ORP Project Managers Meeting
July 23, 2013
2440 Stevens Ctr.
Richland, Washington
Meeting Minutes Transmittal

Purpose: ORP Project Managers Meeting

Figure 1 Drainable Liquid Estimates using averaged properties

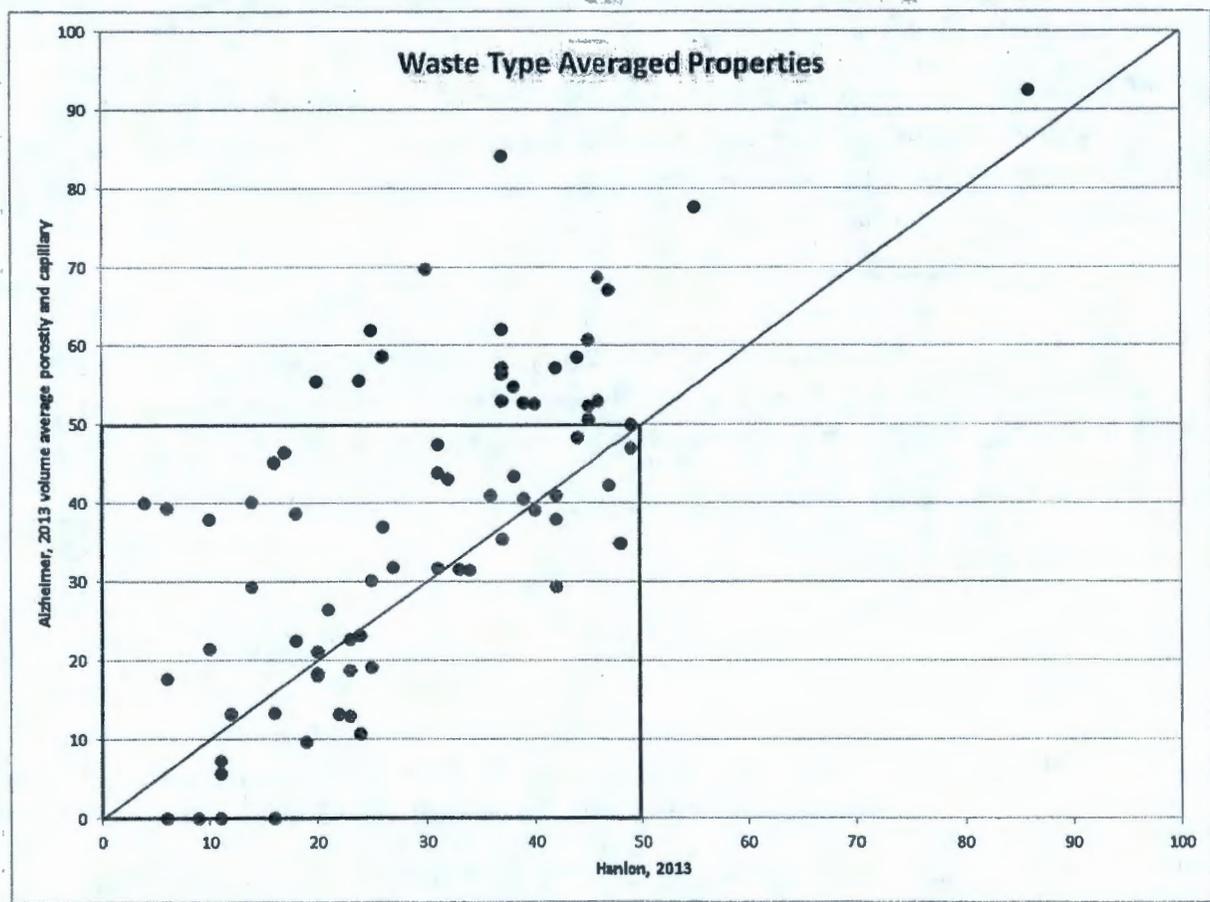
Figure 1 below shows a comparison of my calculated drainable liquid volumes compared to those listed in Hanlon. For some tanks, I predict lower drainable liquid volumes. However, for many tanks I predict higher drainable liquid volumes and many of these volumes are in excess of the 50,000 gallon interim stabilization criteria.

Figure 2 Drainable Liquid Estimates using nominal sludge properties

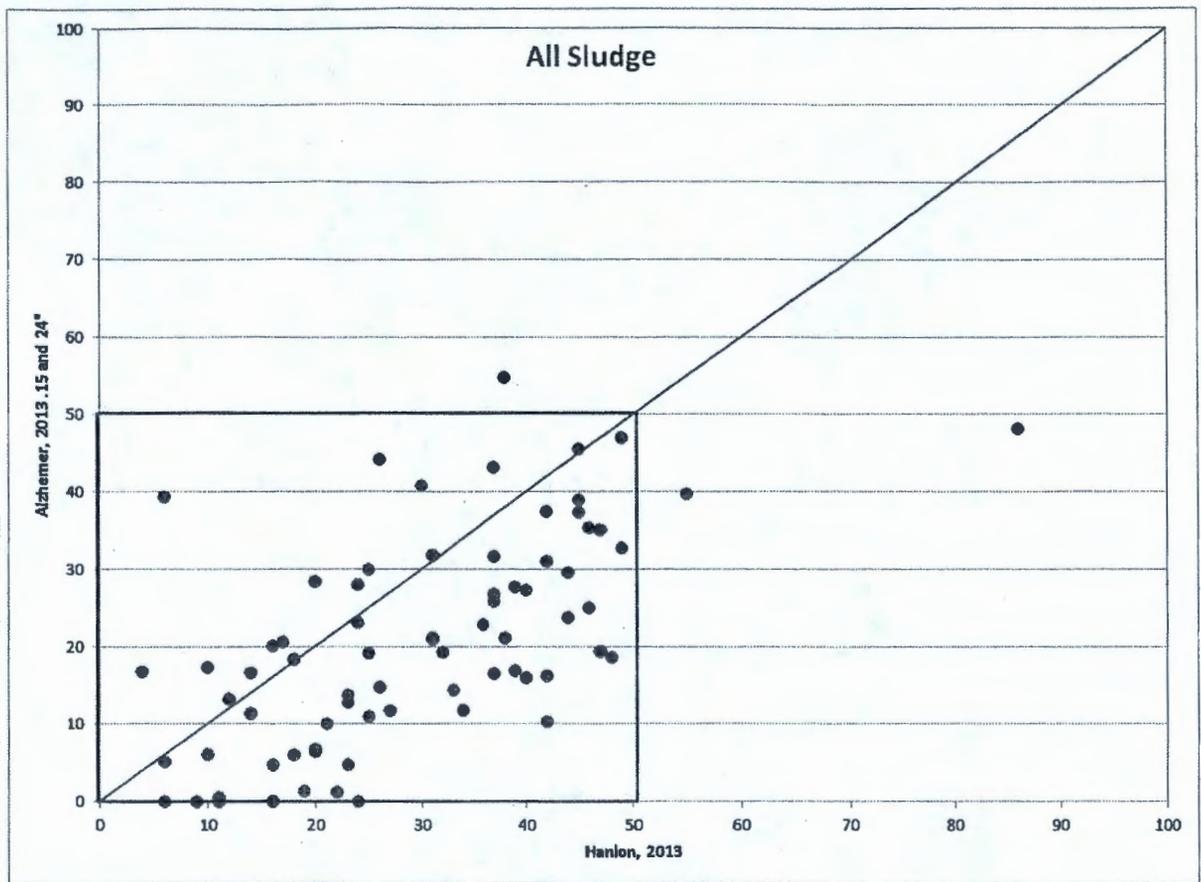
Figure 2 shows the same calculations except that all waste was treated as sludge with a porosity of 0.15 and a capillary height of 24 inches. For this case, only one SST was above the 50,000 gallon limit though it is not one of those currently reported as over 50,000 gallons.

Figure 3 Drainable Liquid Estimates using nominal salt cake properties

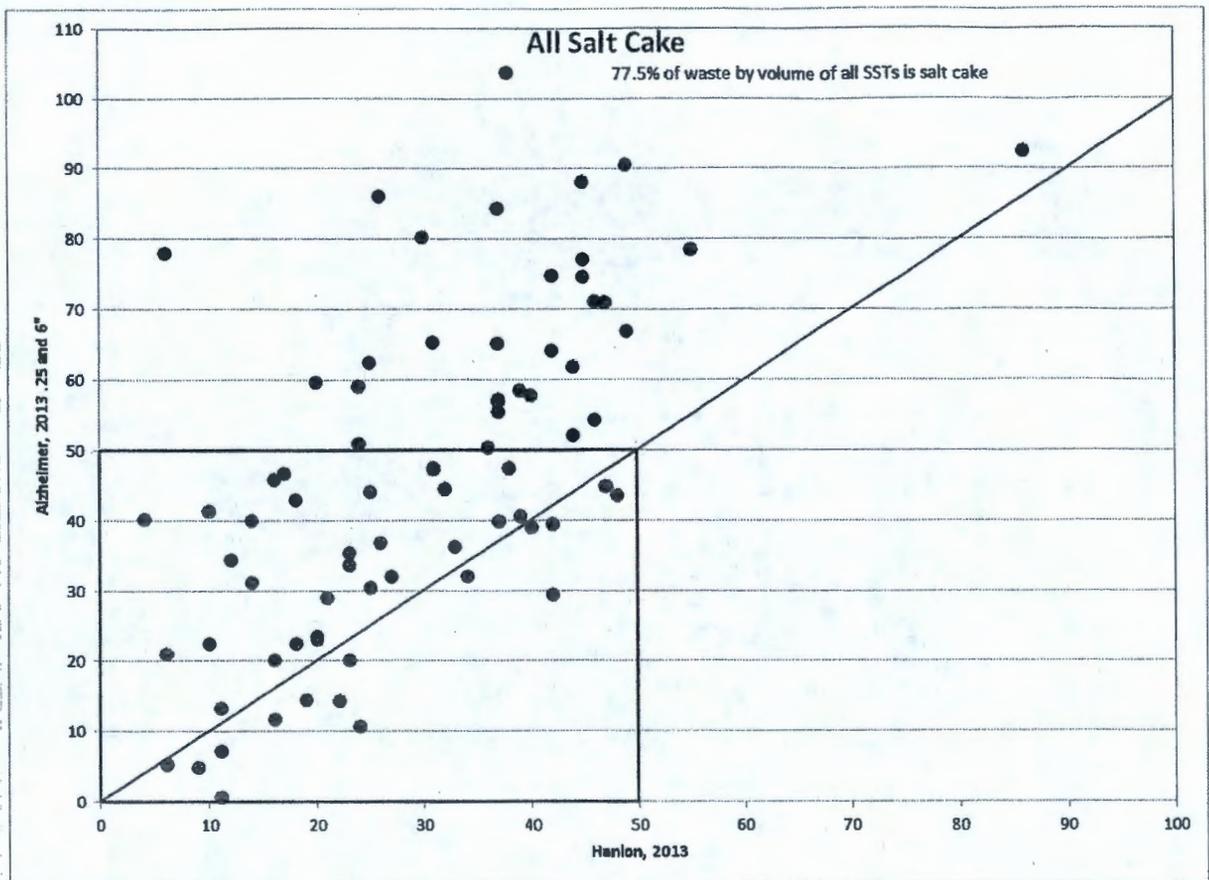
Figure 3 shows the calculations treating all tanks as salt cake with a porosity of 0.25 and a capillary height of 6 inches. Results are fairly similar to the first case with waste averaged properties. This is expected since over 77% of the waste is listed as salt cake.
